Approved for access by the Solid Waste Department.

PROJECT NUMBER: PR-2023009105

APPLICATION NUMBER: SI-2023-01402

ENGINEER'S SEAL	DRAWN BY pm/as
	DATE 09-25-24	
	RETAIL AT 7 BAR ALBUQUERQUE, NM	DRAWING 2023004-SP
	SITE PLAN - EPC (NOT BUILDING PERMIT SET)	SHEET # 4
	TIERRA WEST, LLC 5571 MIDWAY PARK PL NE ALBUQUERQUE, NEW MEXICO 87109 (505) 858-3100 www.tierrawestllc.com	JOB # 2023004

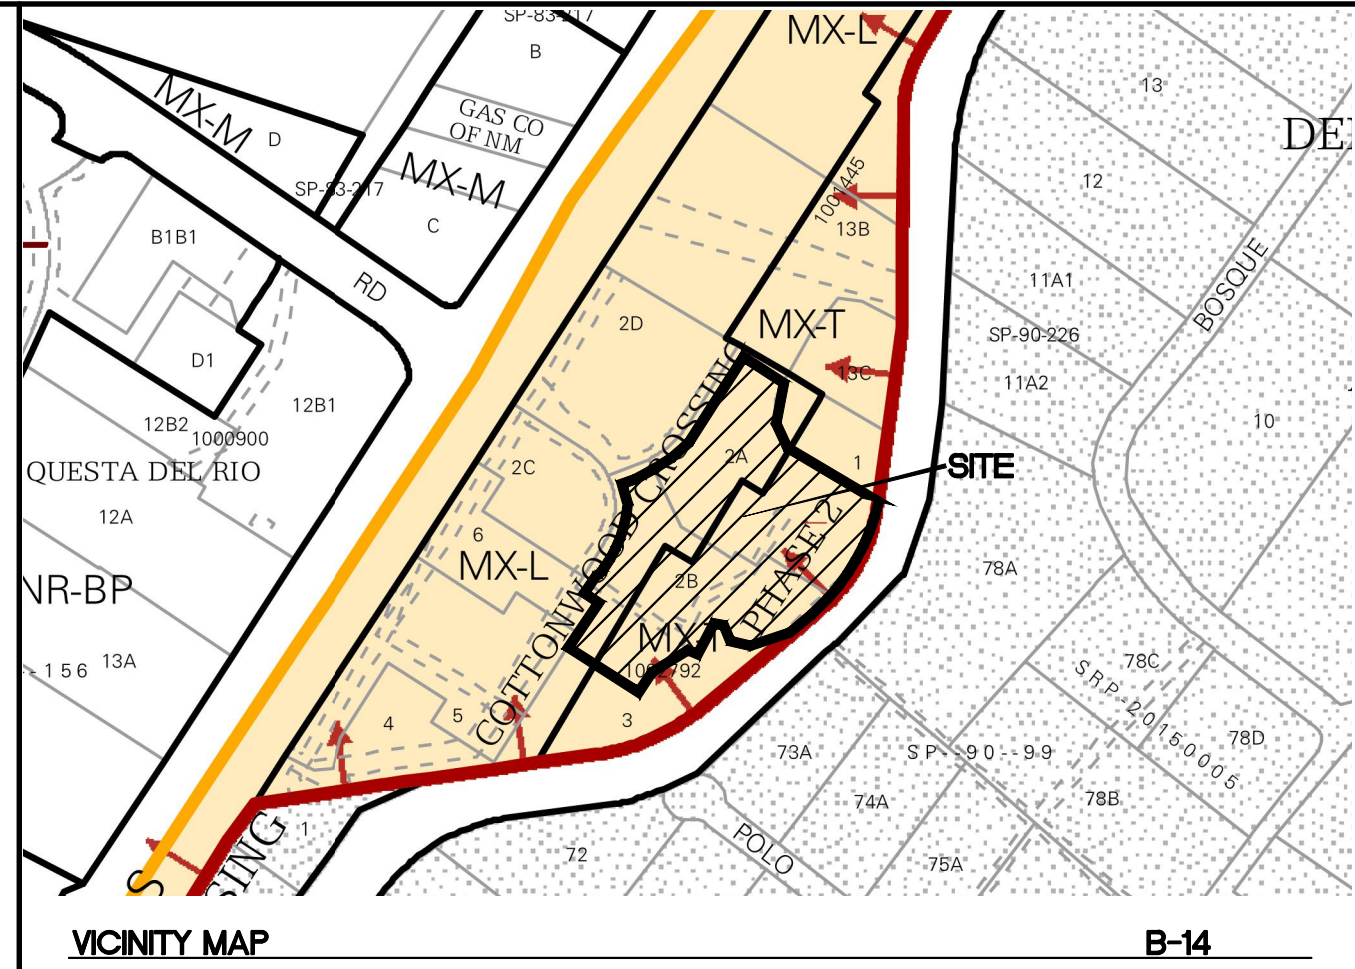
All containers must be made accessible for pick up
between the hours of 5AM and 8PM.

APPROVED FOR 14 RESIDENTIAL TRASH/RECYCLE CARTS FOR 14 TOWNHOMES
EACH LOCATION MUST STORE CARTS ON PROPERTY/ INSIDE GARAGE UNITS
ALL CONTAINERS TO BE ACCESSIBLE BY 7AM THRU 8PM ON SERVICE DAY.
